**Moorhead Area Public Schools Improvements
Robert Asp Elementary School Addition
Moorhead, MN**

**Project No. 13-041
Date: April 4, 2014**

ADDENDUM No. 2

7 DECK BRG. DETAIL - GYMNASIUM
54.2 1" = 1'-0"

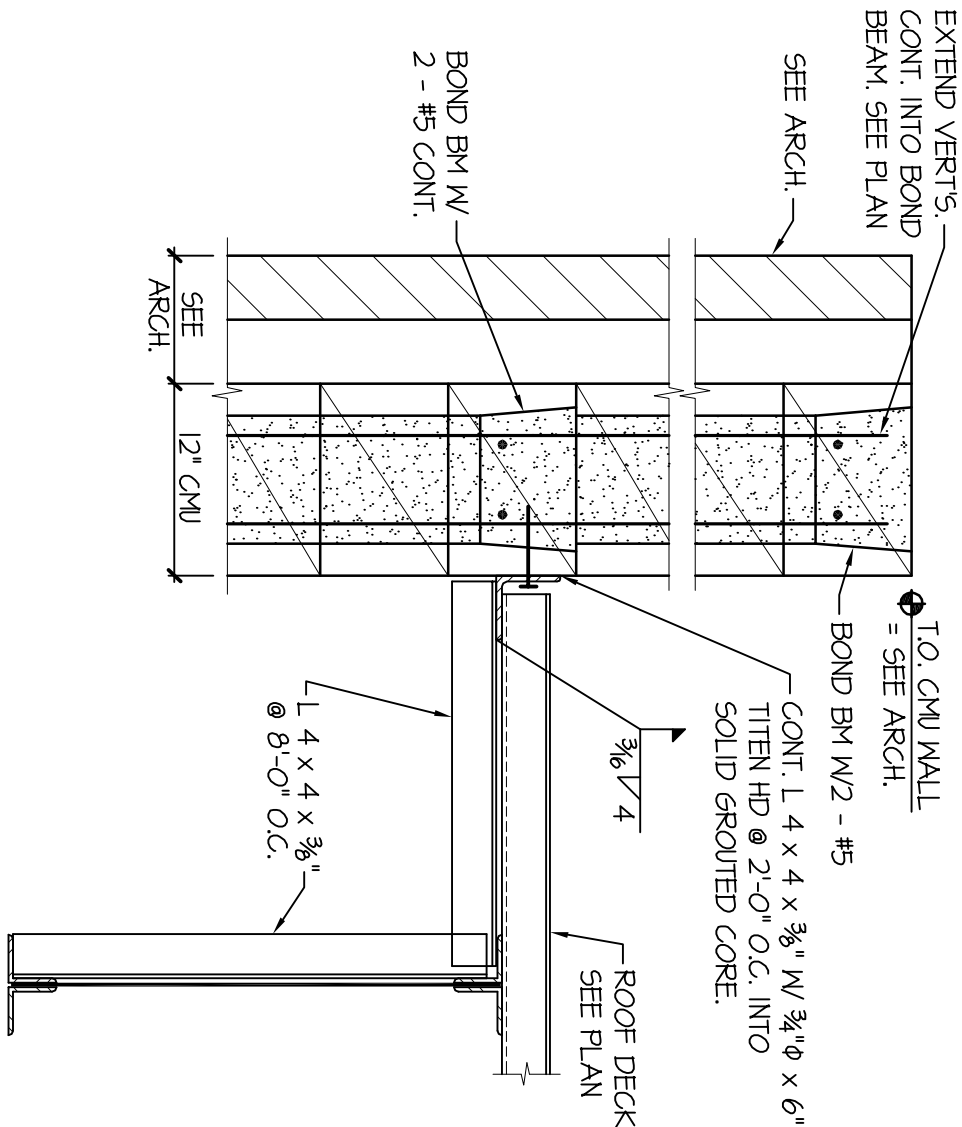
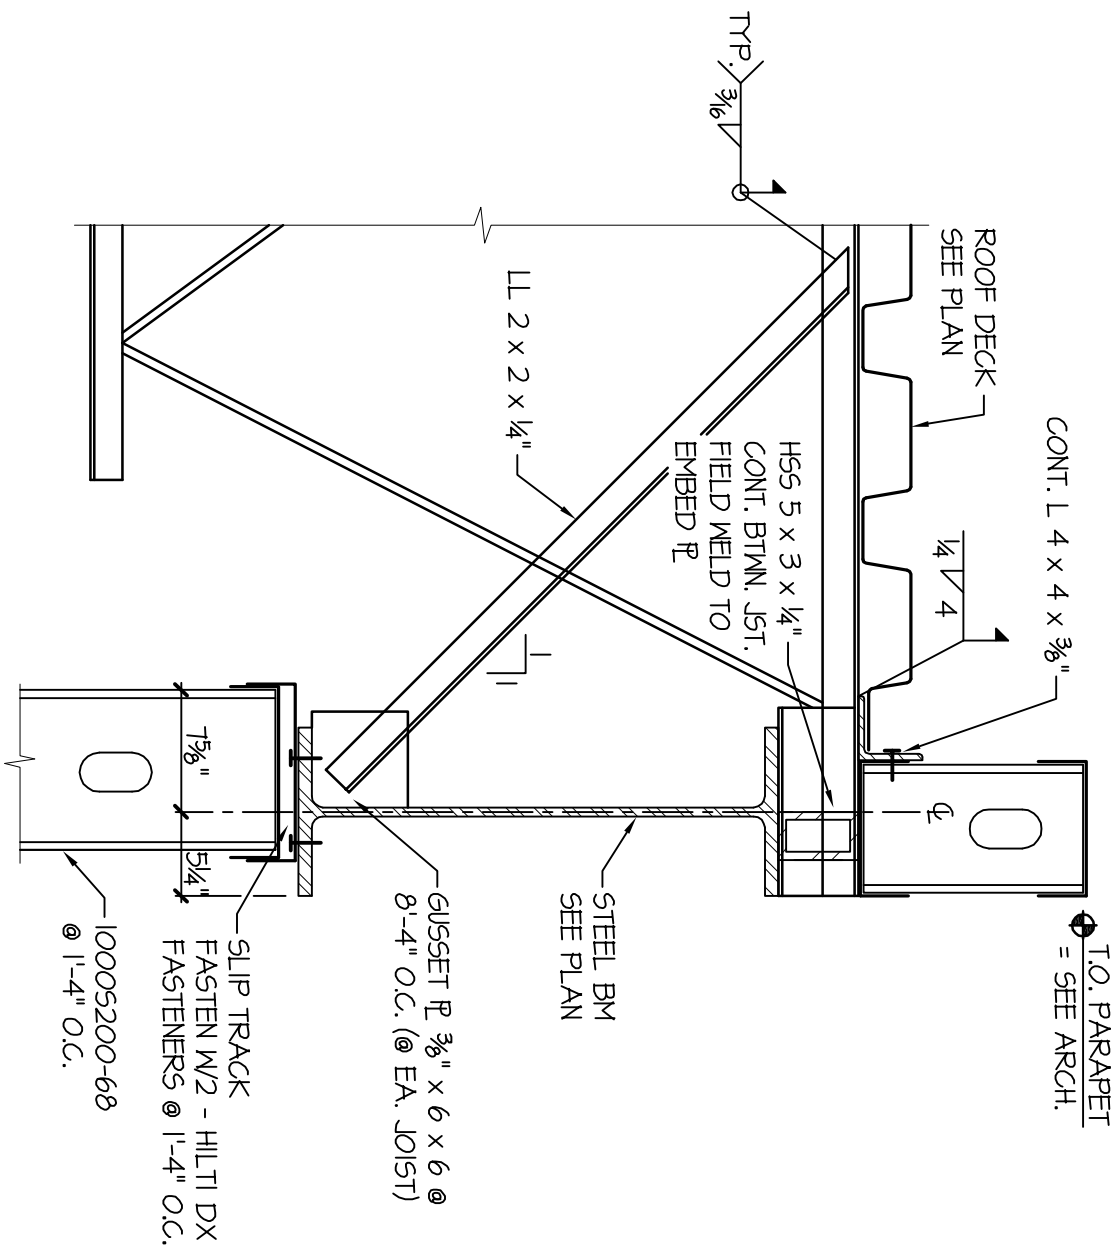
8 JOIST BRG. DETAIL
54.2 1" = 1'-0"

JOIST BRG. DETAIL

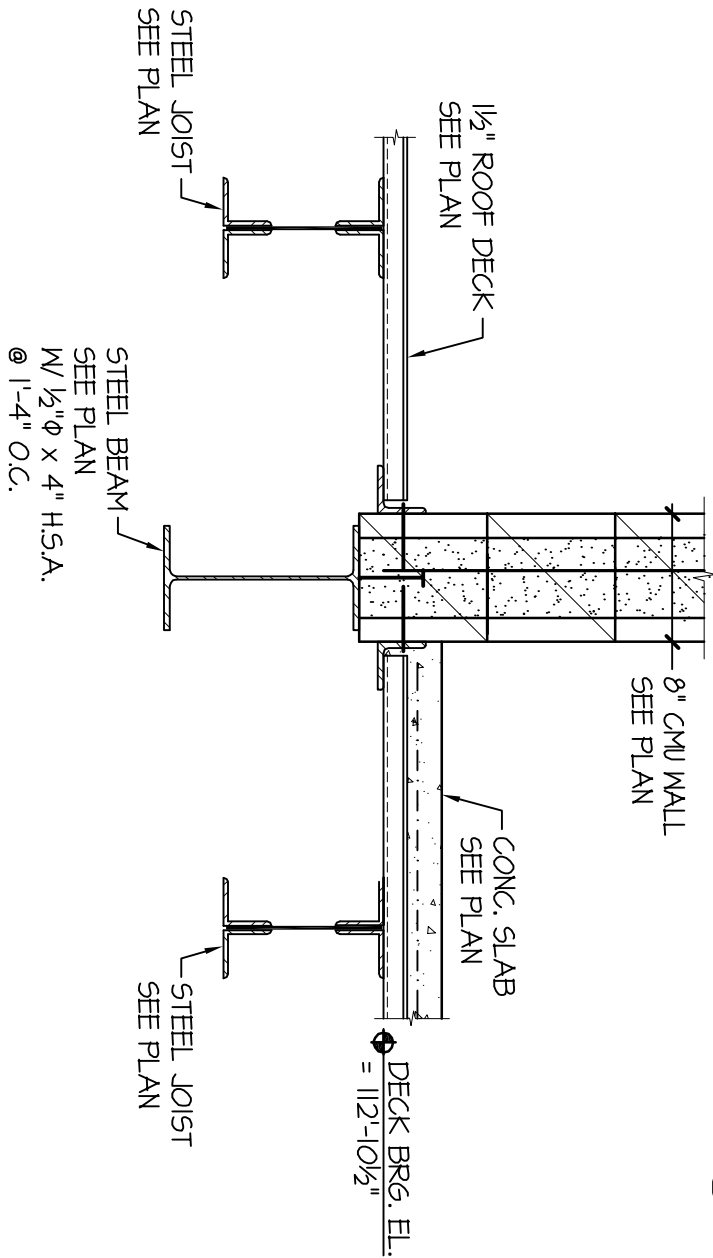
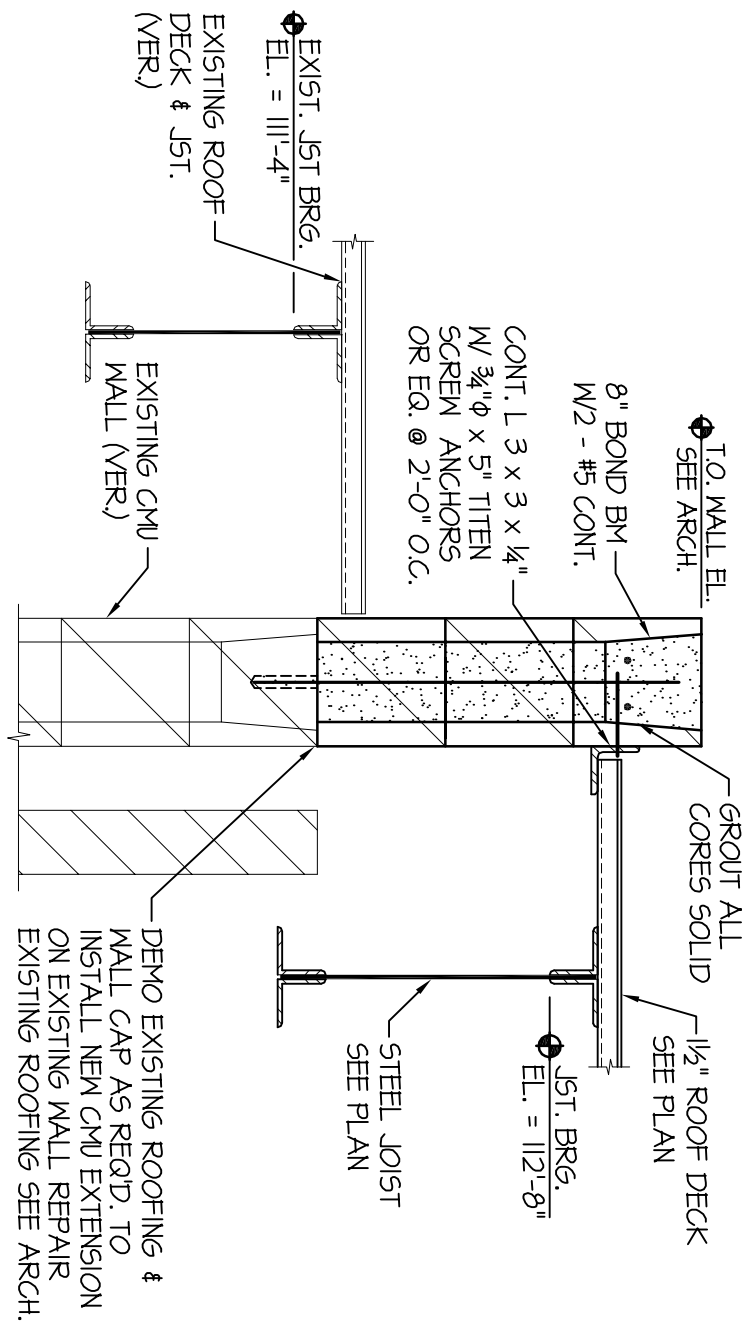
DECK BRG. @ EXIST'G WALL

DECK BRG. DETAIL
